CITY OF AUSTIN – DEVELOPMENT SERVICES DEPARTMENT
SITE PLAN APPLICATION – MASTER COMMENT REPORT

CASE NUMBER: SP-2018-0595C
REVISION #: 00 UPDATE: U3
CASE MANAGER: Randall Rouda PHONE #: 512-974-3338

PROJECT NAME: 1303, 1311 & 1401 South Lamar
LOCATION: 1311 S LAMAR BLVD W/BLDGS & UNITS

OSHA/Texas Safety Code Working Clearances From Overhead Lines For Unqualified Persons

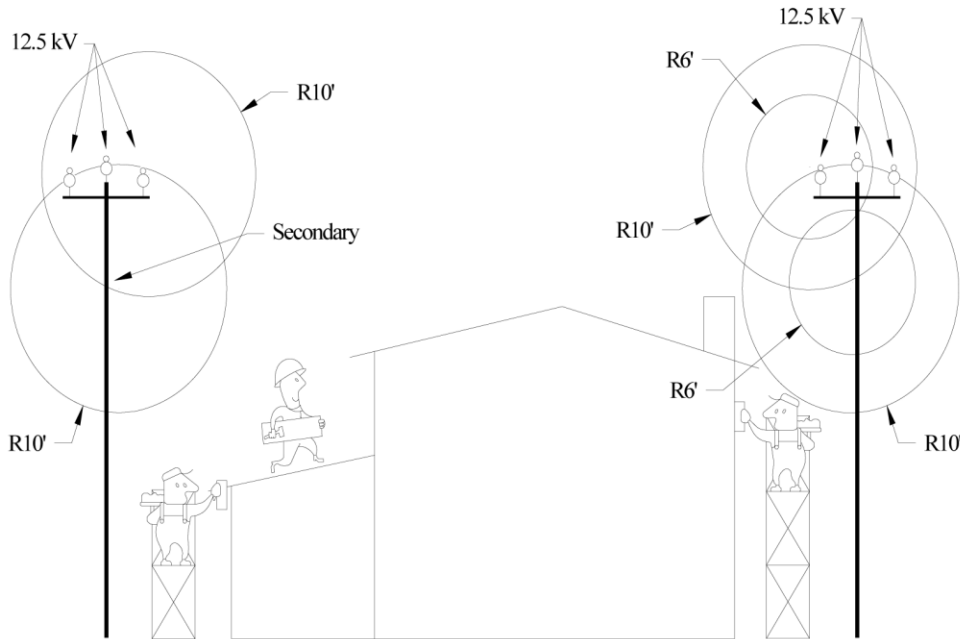
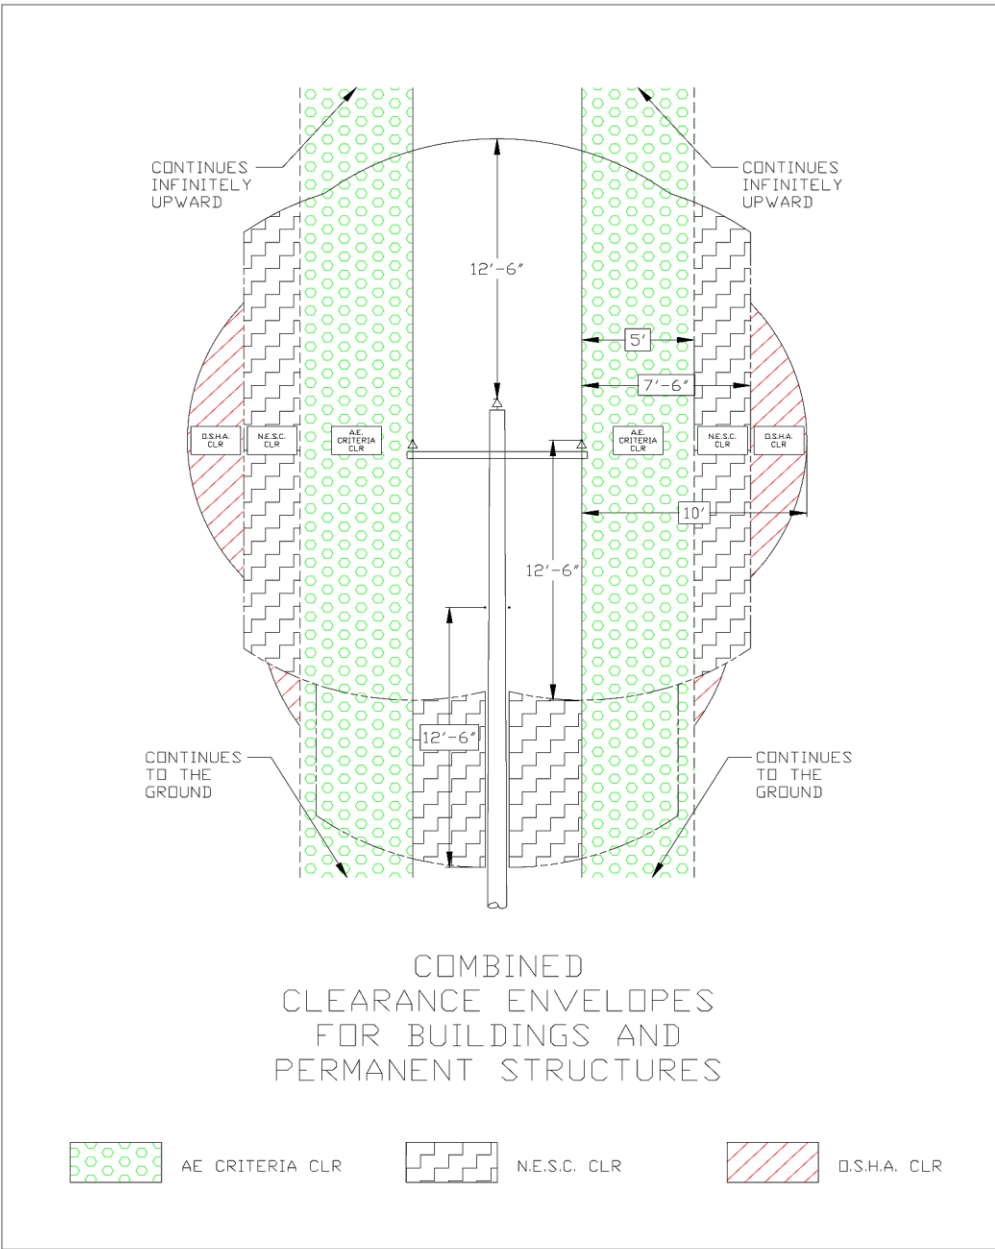
EL 1. The existing overhead facility on the north lot line must be cleared of the proposed building shown. This facility has 4 ft. cross arms from the center of the pole. The following must be shown and building relocated for safety and clearance per AE, NESC and OSHA requirements. A profile plan of each side of the proposed building including overhangs and balconies and the existing electrical pole include the height with all three conductors/neutral. Link of the criteria manual

Update 1: It is understood the developer wishes to relocate those lines. Coordinate with the property owner to the north as well as Christian Pope, Christian.pope@austinenergy.com or ph. 512-505-7674.
 UPDATE2: Relocation of facilities needs approved and shown and clearance above met.
UPDATE3: Comment not addressed.
